3 DESIGN OF STRUCTURES, COMPONENTS, EQUIPMENT AND SYSTEMS

Section 3.1 of the William States Lee III Nuclear Station (WLS) combined license (COL) Final Safety Analysis Report (FSAR), Revision 11, incorporates by reference, Section 3.1, "Conformance with NRC General Design Criteria," of Revision 19 of the AP1000 Design Control Document (DCD). In addition, in the WLS COL FSAR, the applicant provided the following:

Figure 3.7.1.4-1 The WLS horizontal NI FIRS, the AP1000 horizontal certified seismic design response spectra (CSDRS), and the AP1000 horizontal hard rock high frequency spectra (HRHF). (Ref. WLS COL FSAR Revision 9, FSAR 3.7-201)

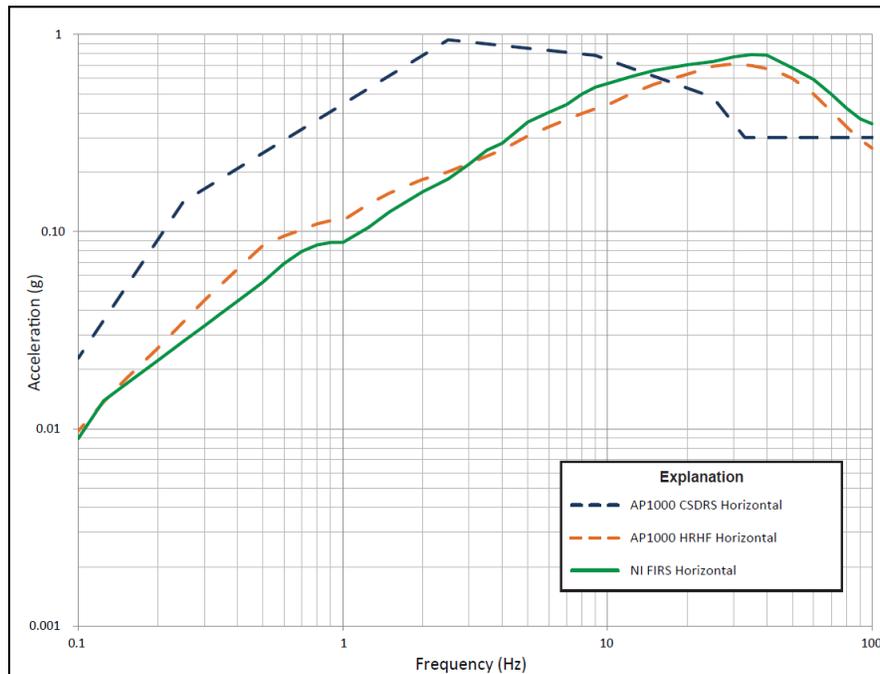
As shown in WLS COL FSAR Figures 3.7-201 (Figure 3.7.1.4-1 of this report) and 3.7-202, the horizontal NI FIRS exceeds the standard horizontal AP1000 CSDRS at frequencies above approximately 14 Hertz (Hz) and the vertical NI FIRS exceeds the CSDRS at frequencies above approximately 16 Hz. The peak ground acceleration (PGA) values for horizontal and vertical NI FIRS are 0.35g and 0.32g, respectively. The applicant also provided a comparison of the NI FIRS to the HRHF spectra. The horizontal NI FIRS exceeds the horizontal AP1000 HRHF spectrum above 3 Hz and the vertical NI FIRS exceeds the vertical HRHF at frequencies between about 3 and 55 Hz and between 80 and 100 Hz. The aforementioned exceedances of

the NI FIRS to both the CSDRS and the HRHF spectra are identified by the applicant as departure WLS DEP 2.0-1. To address this departure, the applicant stated that consistent with AP1000 DCD Section 2.5.2.1, paragraph 4b, a site-specific analysis of the AP1000 has been performed, similar to the analysis described in AP1000 DCD Appendix 3I, to demonstrate that the high frequency spectra exceedances are within the seismic design margin of the AP1000 certified design and will not adversely affect the structures, systems, or components of the plant.

Figure 3.7.1.4-2 The WLS horizontal NI FIRS and the staff's (NRC) horizontal NI FIRS

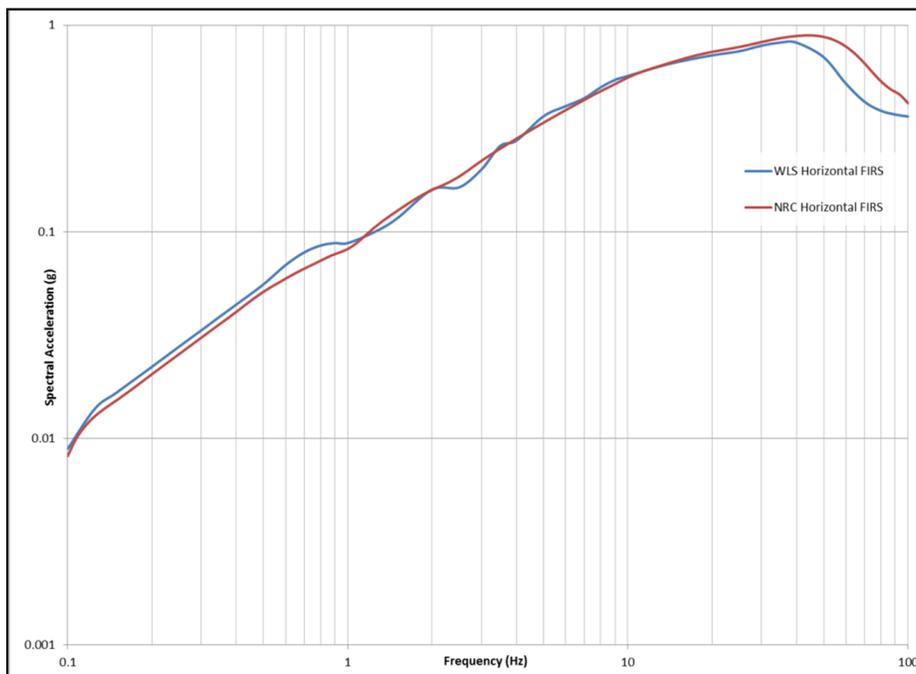
The staff noted a difference between the applicant's and the staff's NI FIRS results at high frequencies (between approximately 40 and 100 Hz). The staff noted the WLS FIRS amplification transfer functions show amplification from approximately 30 to 100 Hz due to the varying fill concrete beneath the WLS proposed structures, which means that at those frequencies the FIRS should have larger spectral accelerations than the WLS site-specific GMRS. In contrast, the WLS NI FIRS is less than the WLS GMRS at high frequencies. To investigate this issue, in RAI 118, Question 03.07.01-6, the staff requested that the applicant assess and evaluate the inconsistency of WLS FIRS amplification transfer functions, FIRS, and the GMRS and to provide a thorough description of the assessment and evaluation. The staff also requested that the applicant explain the basis and justify the conclusions regarding the relationship between the WLS site-specific amplification functions, FIRS, and GMRS.

In a July 24, 2014, response to RAI 118, Question 03.07.01-6, the applicant described that the noted differences in the relationships of the horizontal GMRS and FIRS are attributed to differences in high-frequency interpolation methods used to develop the rock (GMRS) and concrete (FIRS) spectral shapes. In Figure 3.7.1.4-3 of this report, the applicant presented the horizontal GMRS and FIRS A1 from WLS COL FSAR, Sections 2.5.2.6 and 2.5.2.7 (labeled as

Figure 3.7.1.4-3 Comparison of the horizontal GMRS and FIRS A1 from the FSAR (“Orig”) and horizontal GMRS and FIRS A1 using the methodology consistent with that used to develop the FSAR NI FIRS (“Altern”). (Ref. RAI 03.07.01-6 response Figure 9)

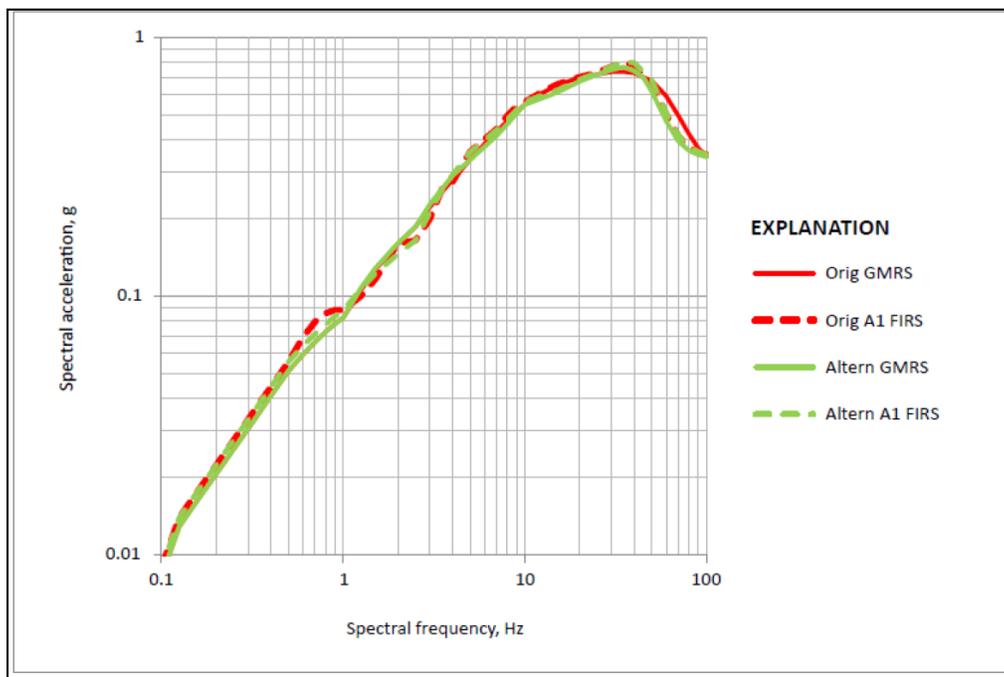
“Orig”) and compared them to alternative calculations of the horizontal GMRS and FIRS A1 based on the FIRS high-frequency interpolation method (“Altern”). The applicant’s RAI response results demonstrated that using the same interpolation methods lead to consistent spectral shapes and resulting in a GMRS that is generally lower than the GMRS presented in WLS COL FSAR Revision 9.

Based on this review, the staff concludes that the WLS COL FSAR Revision 9 horizontal GMRS and FIRS spectra are considered appropriate. Additionally, the staff also concludes that the difference in interpolation methods explains the differences between the WLS NI FIRS and the NRC NI FIRS shown in Figure 3.7.1.4-2 of this report. Accordingly, the staff concludes that the WLS NI FIRS satisfy the acceptance criteria of RG 1.208 and the requirements of 10 CFR 100.23, and considers RAI 118, Question 03.07.01-6 resolved. Based upon its review of WLS COL FSAR Section 2.5.2.7 and 3.7.1.1.1, the applicant’s response to RAI 118, Question 03.07.01-6, and the staff’s confirmatory analysis, the staff concludes that the applicant’s methodology and results for calculations of the site-specific NI FIRS are acceptable and resolved.
